TRAFFIC IMPACT ASSESSMENT

PROPOSED AGED CARE FACILITY

48 VILLAGE BOULEVARD, SOUTHPORT

(RESPONSE TO INFORMATION REQUEST DATED 23 JUNE 2021)

FIGURE 1.1 – PROPOSED RAMP GRADES

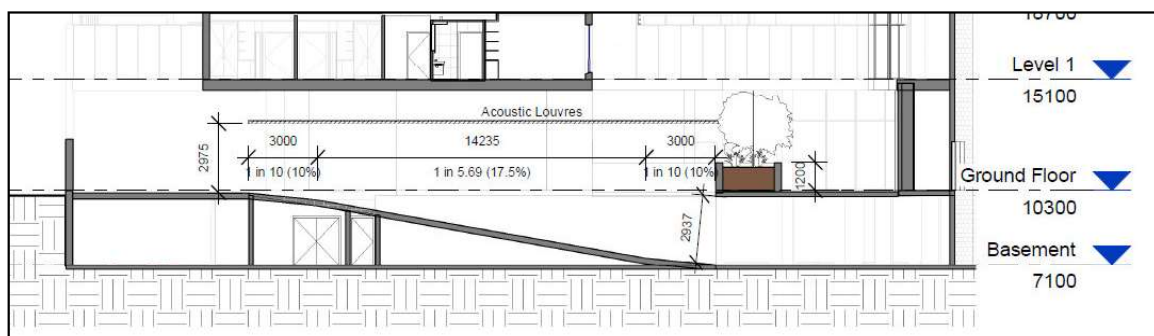
- ii) Identify all ramp grades and transitions. Demonstrate that grades, and changes in grade, comply with AS2890.1.
- iii) EDQ notes pedestrian sight triangles are proposed as 2m wide x 3m deep. These may be reduced to 2.5m deep if desired (meeting AS2890.1).

- ii) As shown in Figure 1.1., the proposed ramp has been designed with a maximum gradient of 1:5, with 3 metre long 1:10 transitions of either side of the maximum grade. Such satisfies AS2890.1:2004 and is considered to be appropriate for the proposed plan of development.

FIGURE 4.5 – 99TH PERCENTILE VEHICLE SWEEP PATH (ACCESS & RAMP)

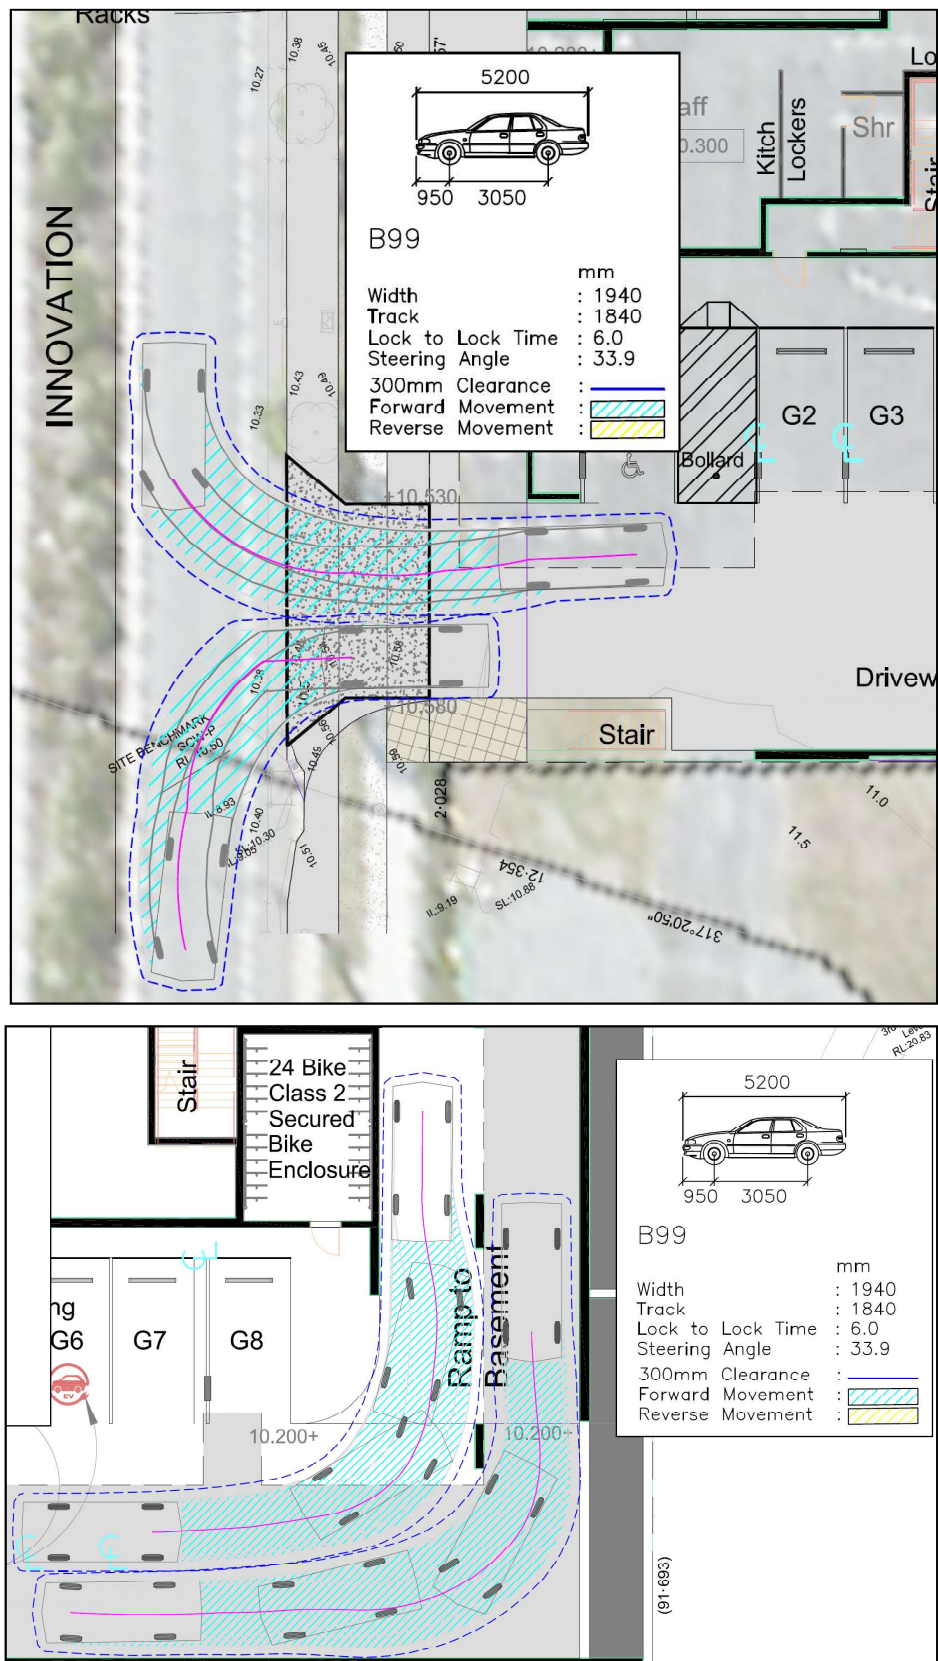
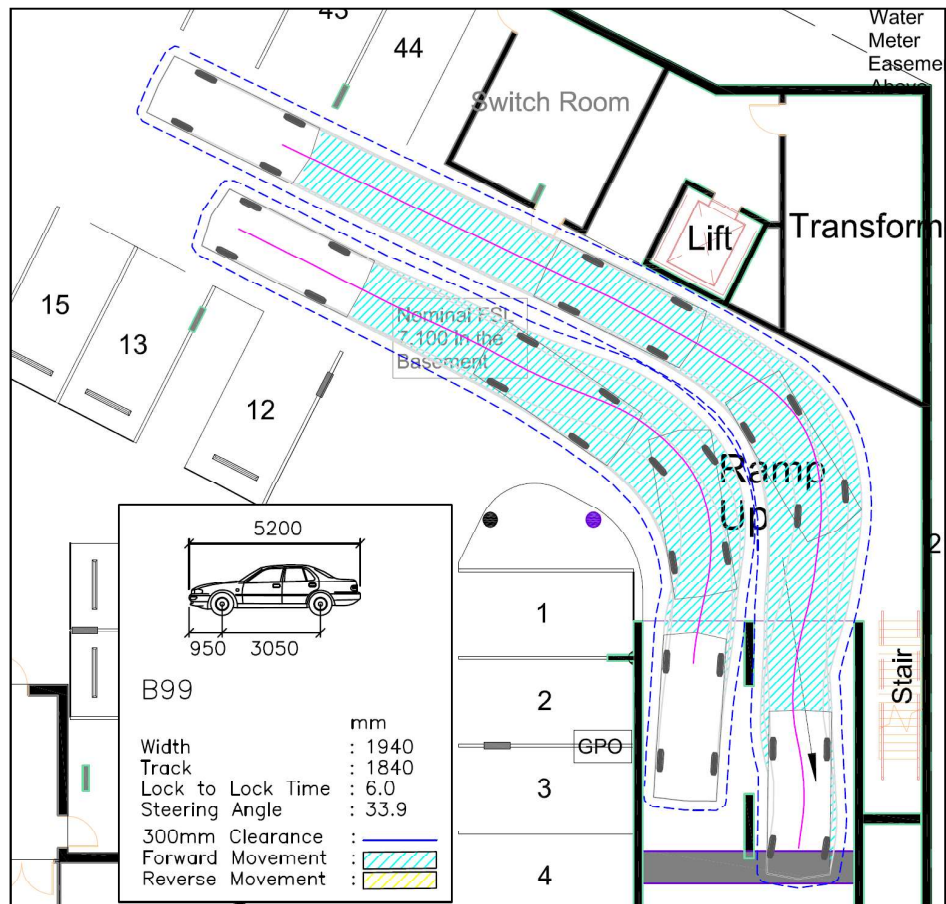
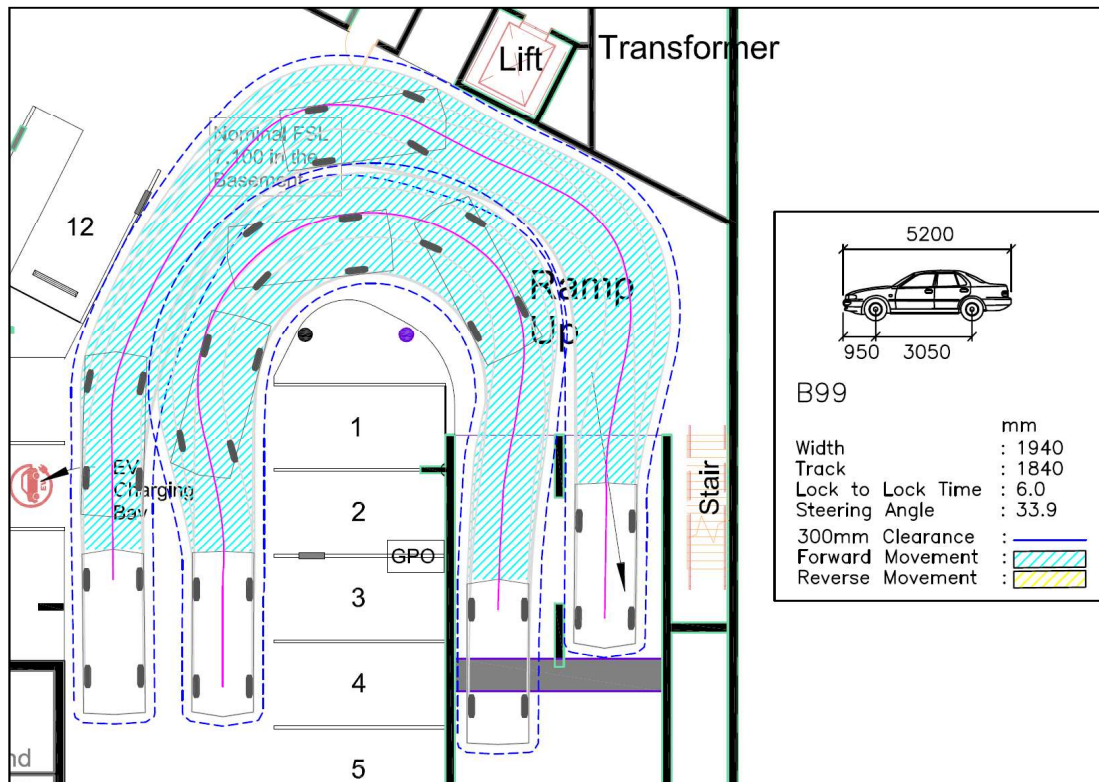
- i) Provide swept paths to demonstrate:
 - i) that two vehicles are able to pass at the top of the basement ramp, while maintaining minimum 300mm clearances at all times.
 - ii) that two vehicles can pass between the bottom of the ramp and the parking aisle within the vicinity of parking spaces #1-10, while maintaining minimum 300mm clearances at all times. Revisions may be required to the geometry at the bottom of the ramp

Note: a B85 and B99 vehicle shall be used for the swept path assessments

- i) The proposed ramp has been adjusted to allow vehicles to pass at the top and bottom whilst maintaining 0.3 metres clearance to obstructions. Revised circulation paths are provided in Section 4 of the report.

FIGURE 7.2 – REFUSE COLLECTION VEHICLE (RCV) MANOEUVRING (INTERNAL)

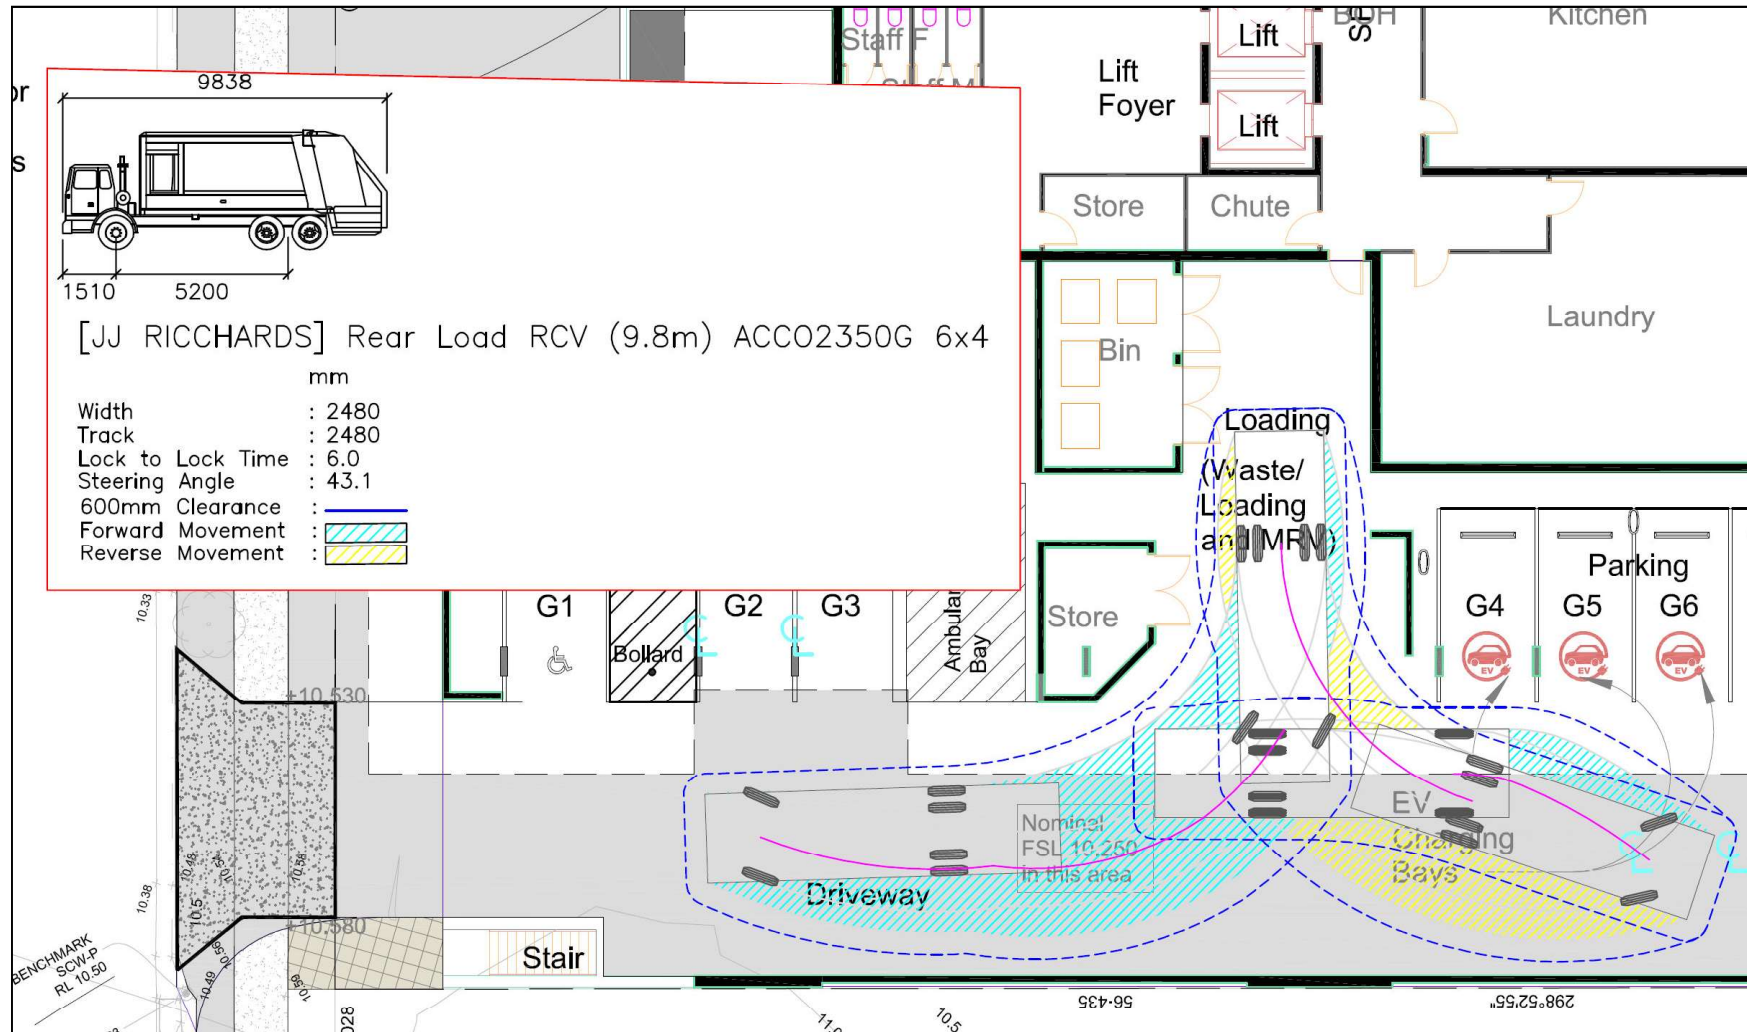
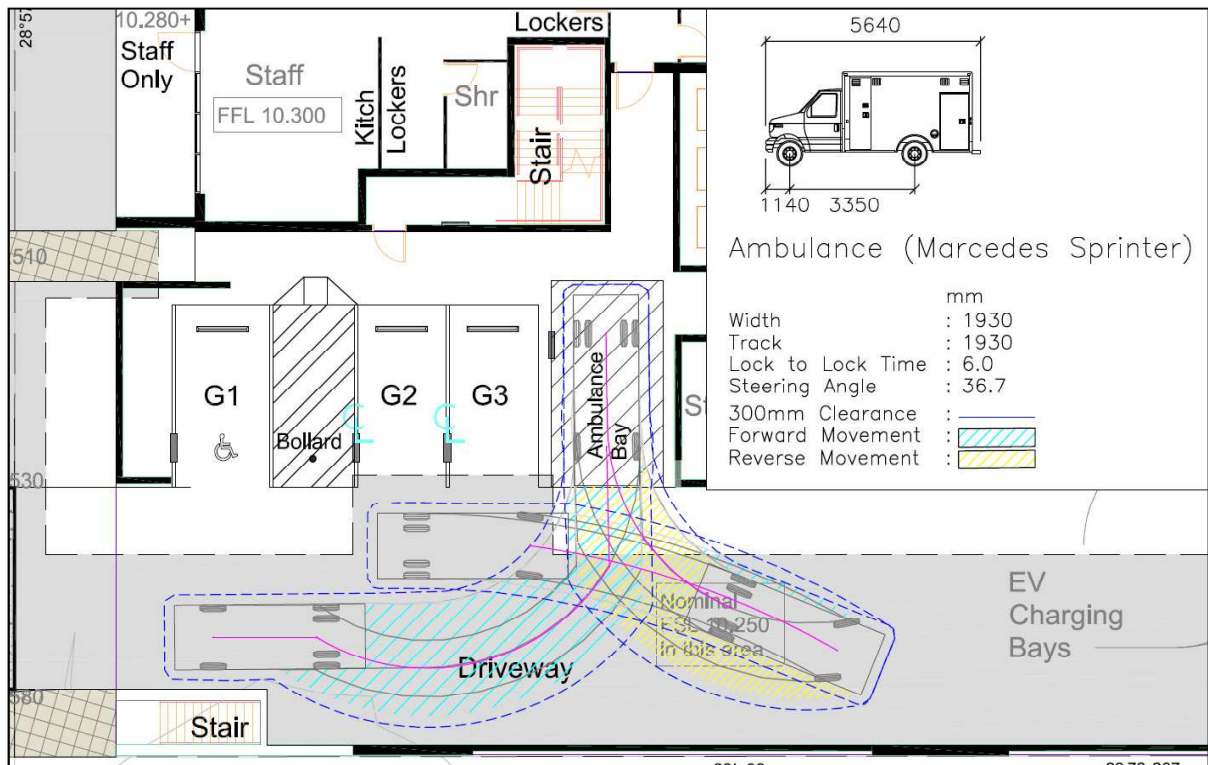
- ii) Provide a separate swept path plan and analysis to clearly demonstrate the 'design service vehicle' (MRV, or as otherwise determined above) is able to access the internal servicing roadways and loading bay and enter and leave the site in a forward gear. The swept path analysis shall comply with AS2890.2, be certified by an RPEQ, and shall include the following:

- o Swept path analysis generated by Auto Turn, Auto Rack or similar.
 - o Demonstrate vehicle specifications in accordance with the 'City Plan Policy – Solid Waste Management' including the kerb-to-kerb turning radius as nominated in Appendix C of SC6.15 City plan policy – solid waste management code

- o Manoeuvring clearances in accordance with AS2890.2 must be clearly depicted on drawings and demonstrate no obstructions exist for all waste servicing manoeuvres.

- o Reversing movements on-site are to be kept to a minimum and access to the development from the road is to comply with AS2890.2.

The proposal has been designed to allow servicing by a private contractor. As shown in Figures 7.1 and 7.2, the proposed service area is suitable for an 9.8 metre long rear loading refuse truck to reverse into the loading bay to service the site and exit the development in a forward gear, whilst maintaining adequate clearance to obstruction at all times.
